RE: **Winrock Road Town Center**
2100 Louisiana Blvd NE
Drainage Master Plan- Drainage Implementation Plan
Engineer's Stamp Date: 5/16/19
Hydrology File: J19D058

Based on submittal received on 5/17/19, the Drainage Implementation Plan cannot be approved for Site Plan for Building Permit until the following are corrected:

RE: Winrock Town Center Drainage Implementation Plan
Hydrology File: J19D058

WINROCK TOWN CENTER DRAINAGE IMPLEMENTATION PLAN

WINROCK TOWN CENTER			
PHASE B INFRASTRUCTURE IMPROVEMENTS			
TITLE: STORM DRAIN AP-D 400 & 500			
Design Review Committee	City Engineer	Ms./Day/Yr.	Ms./Day/Yr.
Last Update			
City Project No.	Zone Map No.	Sheet	Of
4553.90	J-19-Z		EXHIBIT 7

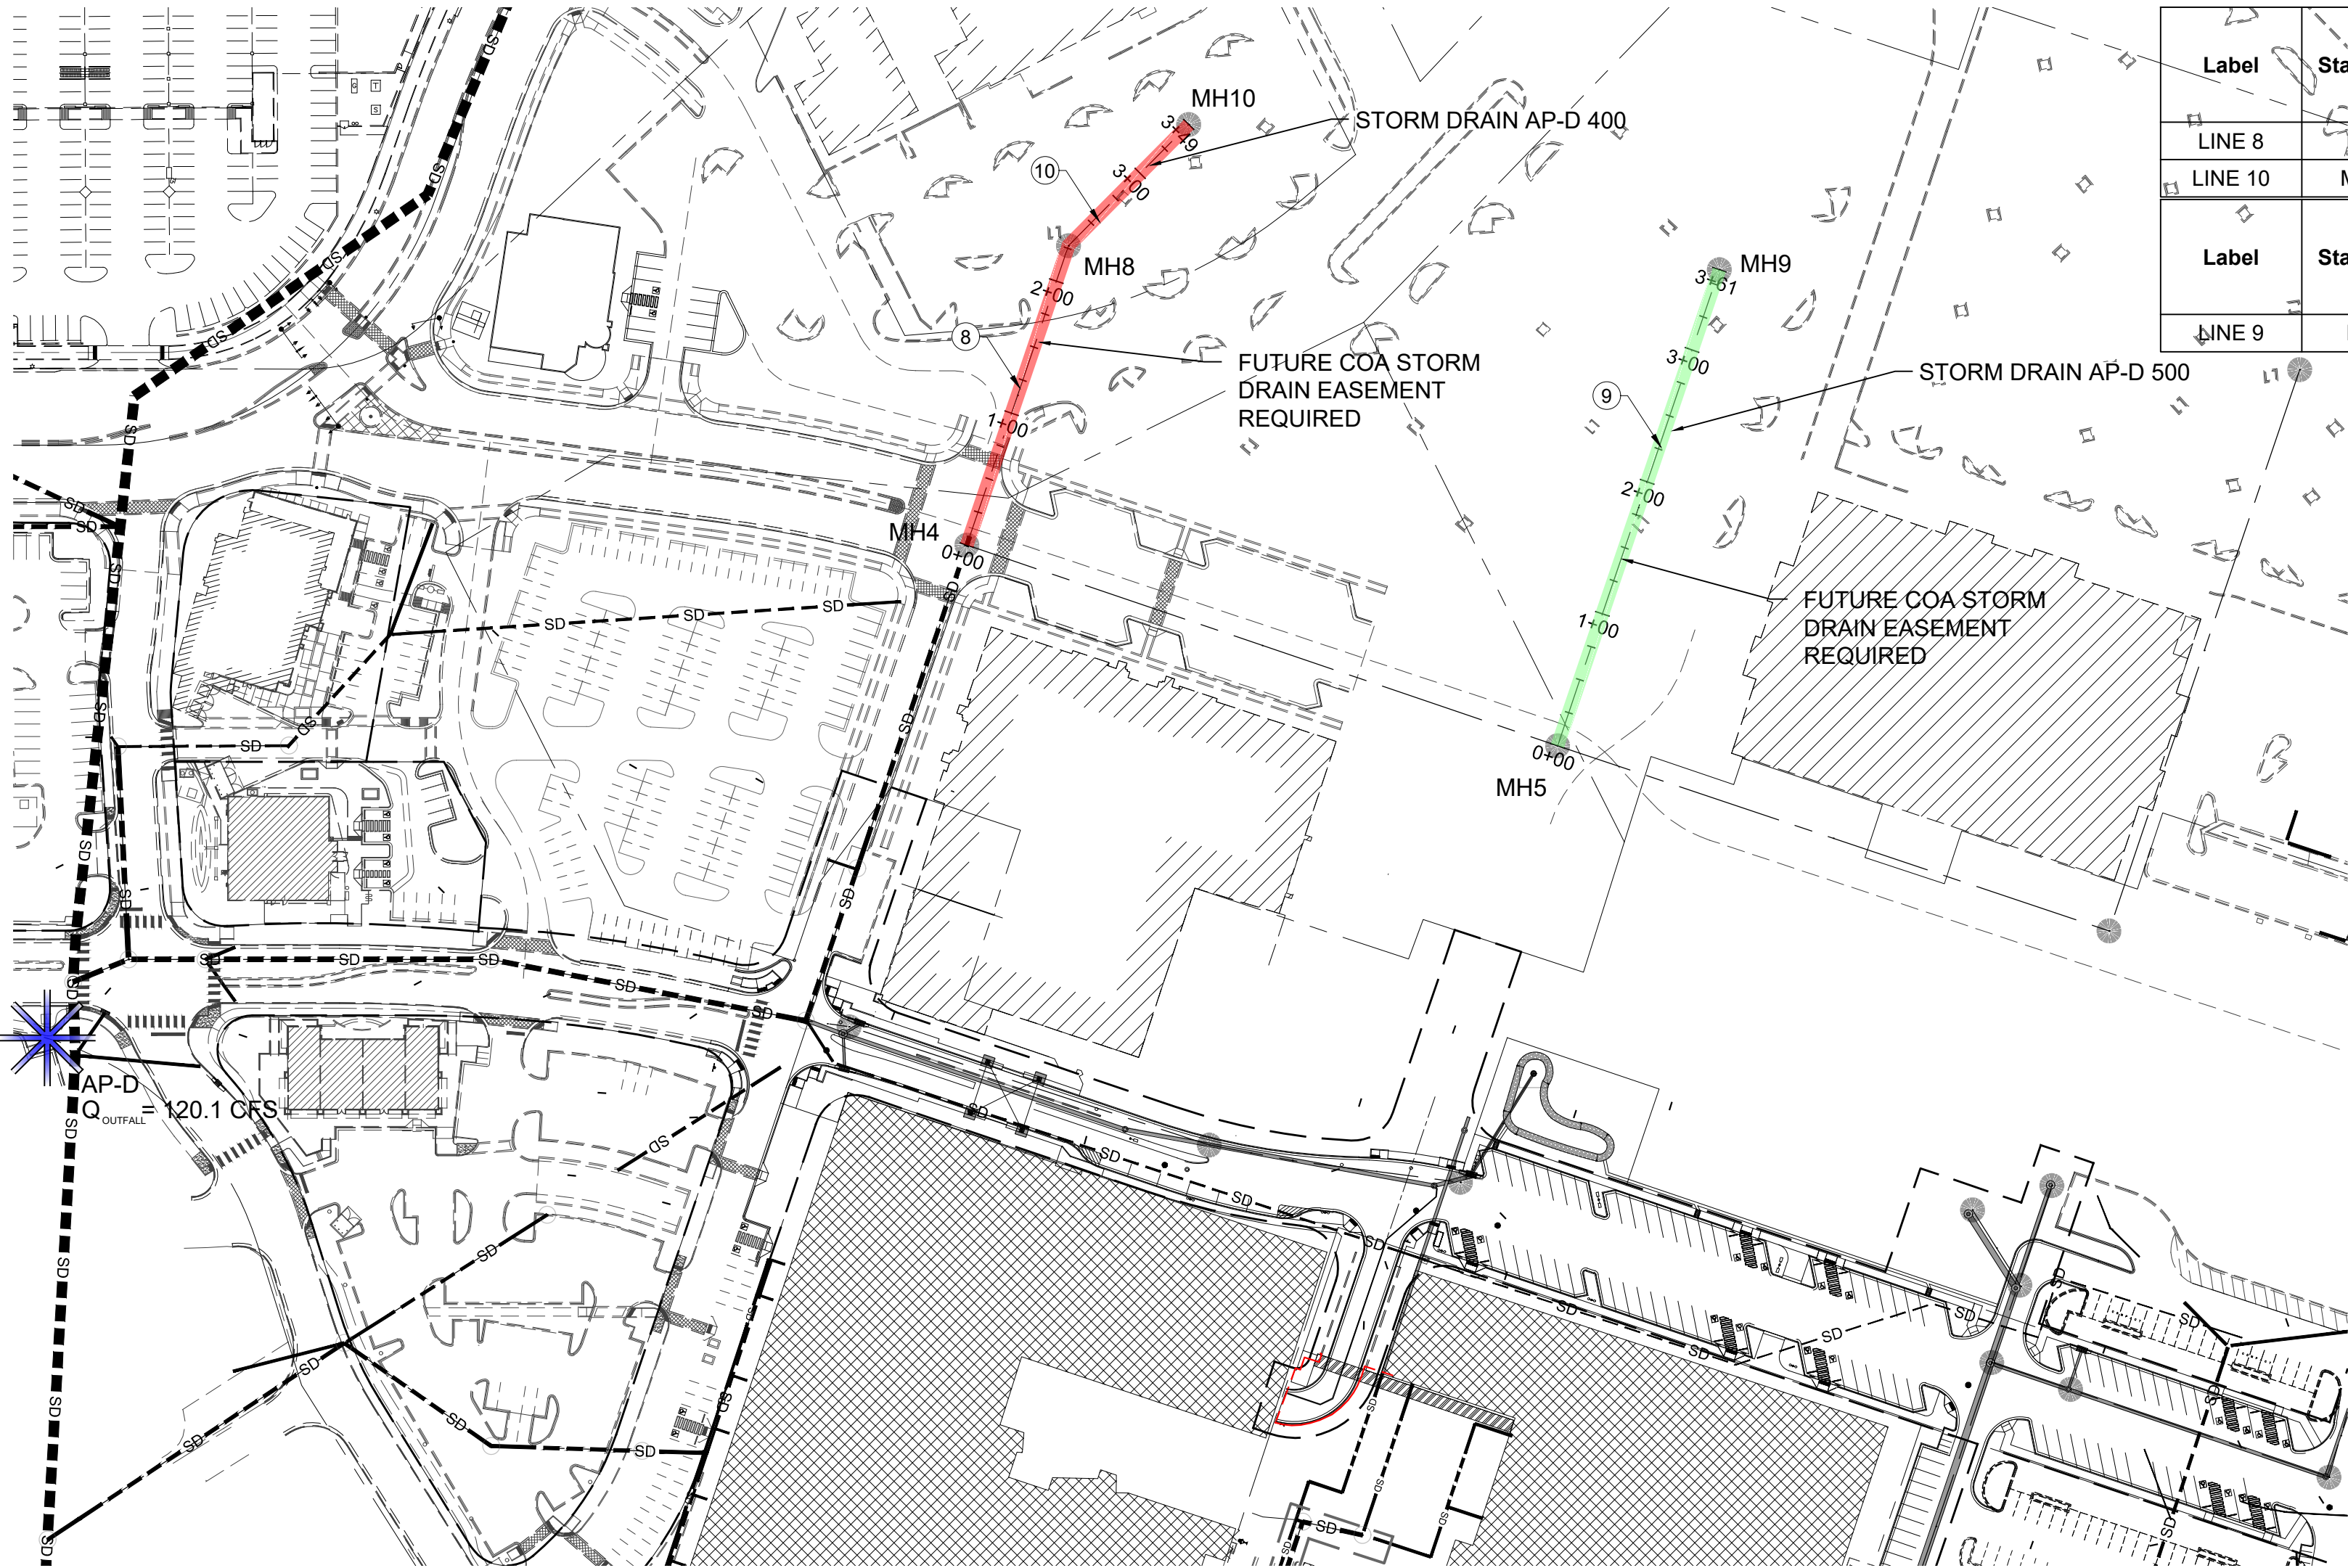
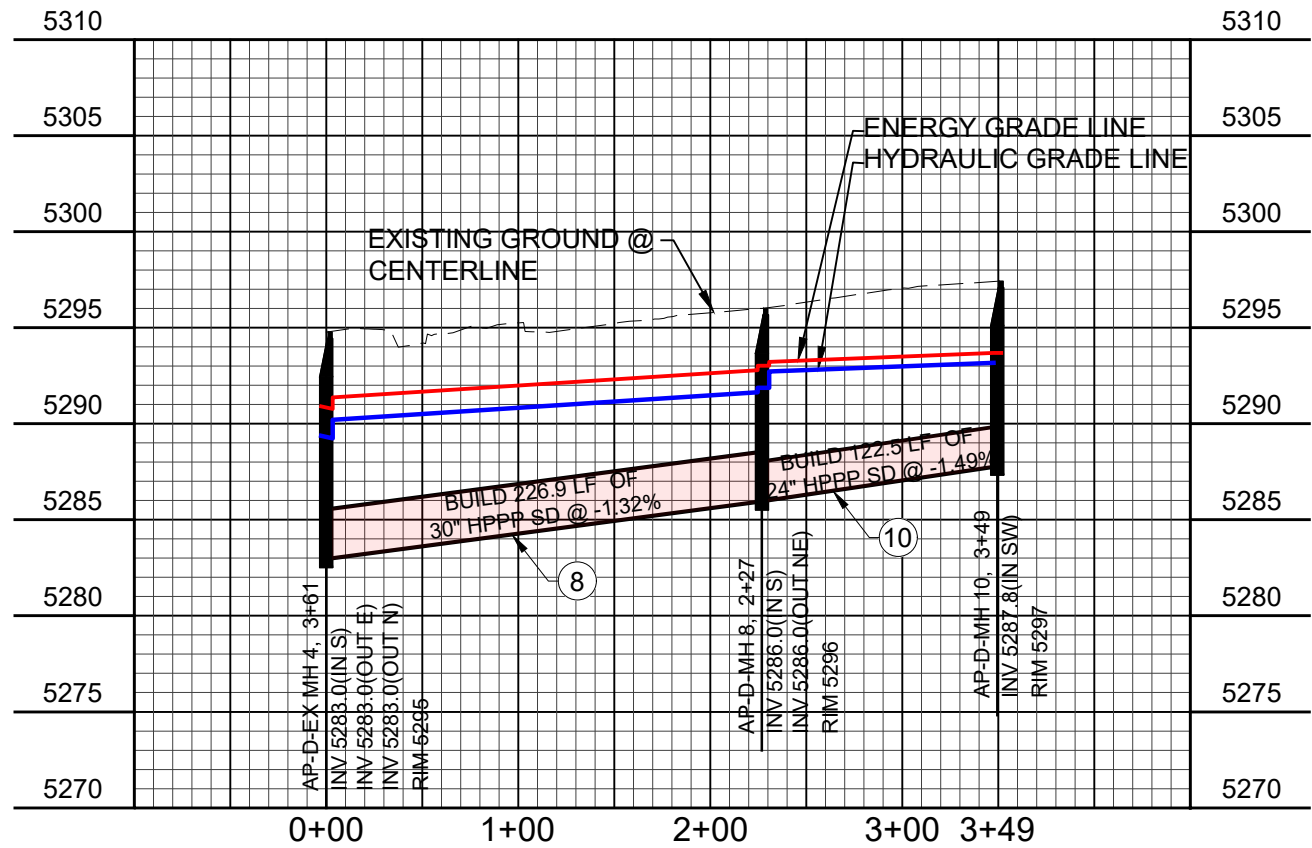
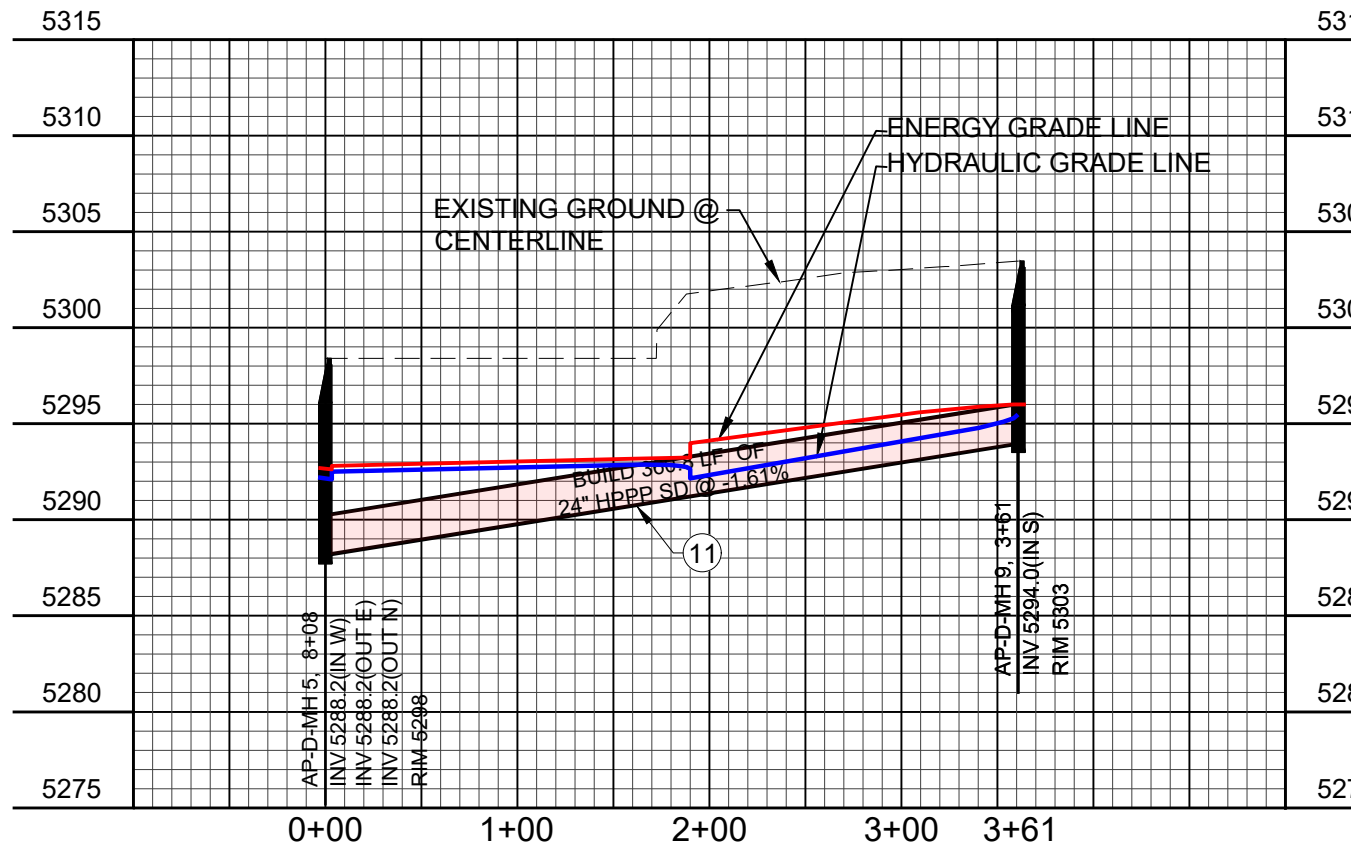
- f. On Exhibit 6, pipe 6 is called out as 30" in profile and 30" on the exhibit 1 table, but is 24" in the table.
 - g. On Exhibit 7, pipe 8 is called out as 30" in profile, but is 36" in the table and 36" on the exhibit 1 table

Design Review Committee	City Engineer	Last Update	Mo./Day/Yr.	Mo./Day/Yr.
City Project No.		Zone Map No.	Sheet	Of
4553.90		J-19-Z		EXHIBIT 8

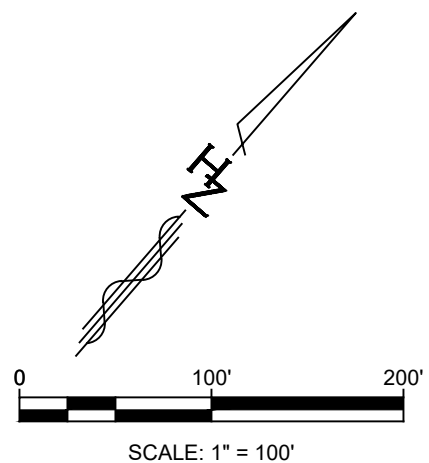
- h. On Exhibit 8, the table and profile and table on Exhibit 1 don't match:
 - i. pipe sizes are inconsistent between the table and profile and the exhibit 1 table;

- ii. pipe type is shown as HPPP (isn't it RCP here?);
 - iii. manhole labels in the table are inconstant with the profile and exhibit 1 profile
